TDK Corporation
Electronic Components Business Company
Piezo & Protection Devices BG

Subject: Nebulizer product - Information of change of a screw lock

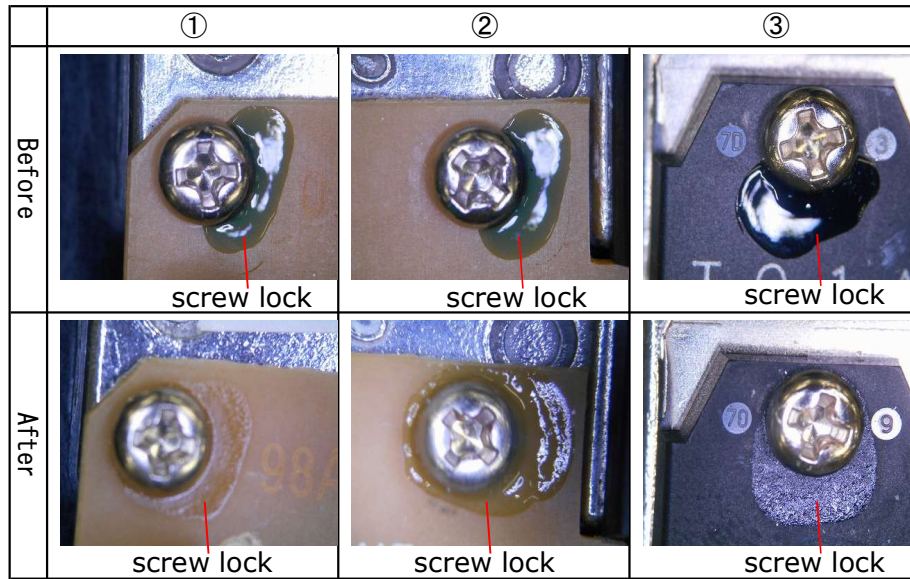
We will change to a screw lock which comply with VOC standards.

While there is a change in appearance color, the fixed strength is equivalent.

There is no a change in the shape, characteristics and specs of the nebulizer unit associated with this change.

We plan to replace sequentially from April 2021.

As for the change of adhesive, since it doesn't affect to the characteristics and specs of the product, We would like to make a running change.
